## HYDROGRAPHIC TITLE SHEET

**H11089**

General Locality: **St. Johns River**

Sub-Locality: ~~East and South of Jacksonville~~ **Chaseville to Hendricks Point**

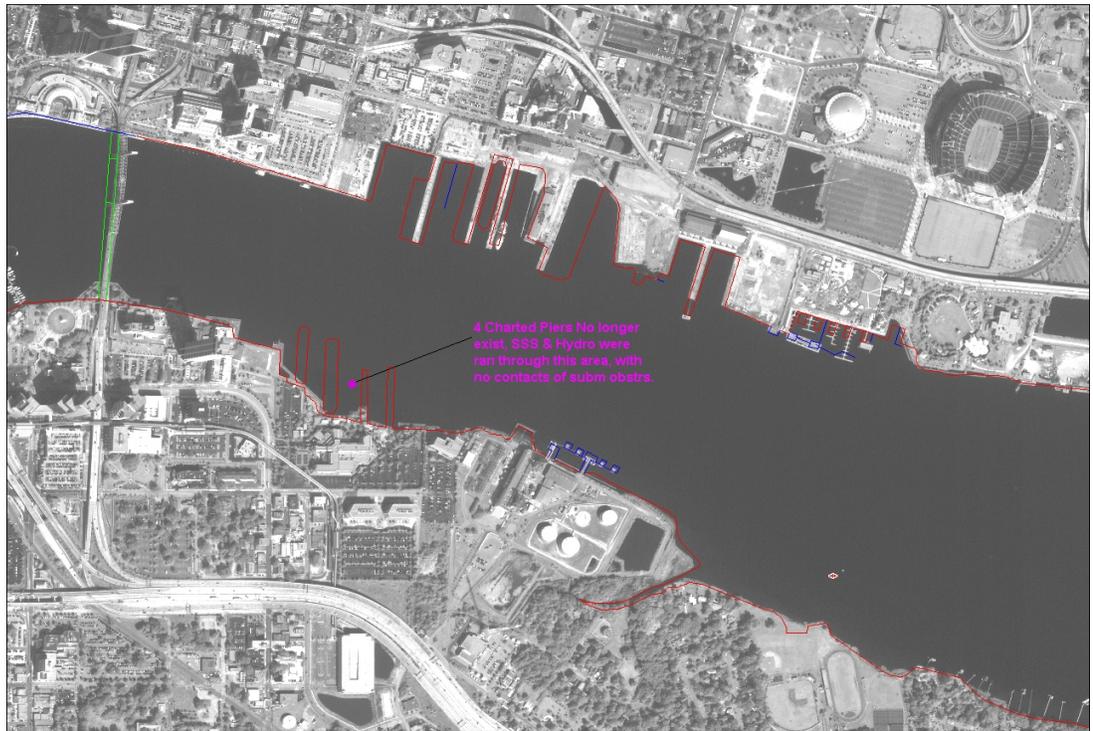
In general survey soundings compared favorably with the charted soundings within one to three feet. There are some areas of change in the controlling depths investigated during H-11089.

1. A 50 foot report at 30°19'19.4"N, 081°38'55.6"W, now shows soundings in the ~~±2 7~~ to ~~25~~ **50** foot range. This report should be removed and replaced by current survey soundings. **concur**

2. A 44 foot report at 30°19'15.1"N, 081°38'41.3"W, now shows soundings in the ~~±2 3~~ to ~~±2~~ **33** foot range. This report should be removed and replaced by current survey soundings. **concur**

3. A 19 foot 1990 report ~~1990~~ at 30°19'22.2"N, 081°37'34.8"W, is now an active floating drydock with depths observed in the 25 foot range. This report should be removed and replaced by current survey soundings. **Do not concur. See Section D.1.1. of the Evaluation Report.**

4. The 18 foot contour at 30°19'01.0" N, 081°37'47.9"W, has receded 190 meters towards shore at 318 degrees. A tug and barge company in this vicinity has requested an update to the chart in this region for current soundings. **Concur. It is recommended that present survey soundings supersede the charted soundings in this area.**

5. The blue charted region at 30°18'56.5"N, 081°37'46.6"W, near F&E R "80 was found to have ~~±7 19~~ foot depths in the vicinity as charted. **Concur. . It is recommended that present survey soundings supersede the charted soundings in this area.**

6. The controlling depth access at the entrance to the Arlington River is now ~~one foot~~ **two feet** or less in the common area. **Concur. It is recommended that present survey soundings supersede the charted soundings in this area.**

7. An 8 foot sounding exists at 30°19'32.5"N, 081°37'06.3"W, this area was identified during 200% side scan sonar and should be charted as a eight foot obstruction. The charted surrounding soundings are ~~±0 21~~ to ~~±2 25~~ feet. The hydrographer recommends charting a bulls eye sounding at this location. **concur with clarification. See Section D.1.2. of the Evaluation Report.**

8. There are 27 foot soundings in Terminal Channel near 30°20'17.3"N, 081°37' 19.3"W, the chart tabulation for this region according to the USACOE is 26.1 left outside quarter, 30.2 left inside quarter, 31.5 right inside quarter, 28.1 on the right outside quarter and a controlling project depth of 34-38 feet. **Do not concur. See Section D.1.6. of the Evaluation Report.**

1. Item number D.1.3. of the Descriptive Report states that the "19 FT 1990" note in 30°19'22.2"N, 081°37'34.8"W, is now an active floating drydock with depths observed in the 25 foot range. The most recent edition of chart 11491 shows the notation updated to 19 FT 2002. Clarification was made from a phone conversation with N/CS26 Nautical Data Branch as

follows: The source for the 19 FT 2002 note is a Corps of Engineers (COE) survey, conducted 2/03, which found 19ft soundings in that area. This survey was conducted subsequent to the present survey, therefore, no changes in charting are recommended unless other information indicates otherwise.

2. Item number D.1.7. of the Descriptive Report states that an uncharted 8 ft dangerous obstruction was found by the present survey in Latitude 30°19'32.5"N, Longitude 81°37'06.3"W. This item was submitted as a Danger to Navigation and is charted on the latest edition of the chart. During office processing of the survey it was determined that the obstruction actually has a least depth of 12 feet in Latitude 30°19'32.49"N, Longitude 81°37'06.76"W. It is recommended that the charted 8 ft obstruction with danger curve be deleted and a 12 ft obstruction with danger curve be charted in the present survey location.

6. Item number D.1.8. of the Descriptive Report states that the present survey depths in Terminal Channel, in the vicinity of latitude 30°20'24.6"N, longitude 081°37'17.6"W, were shoaler than the depths in the charted tabulations. These tabulations have been updated on the latest edition of the chart to reflect data from 2003 surveys conducted by the Army Corps of Engineers (ACOE). The ACOE data is subsequent to present survey data and indicates that dredging has taken place within the confines of Terminal Channel. It is recommended that the controlling depths be retained as charted.
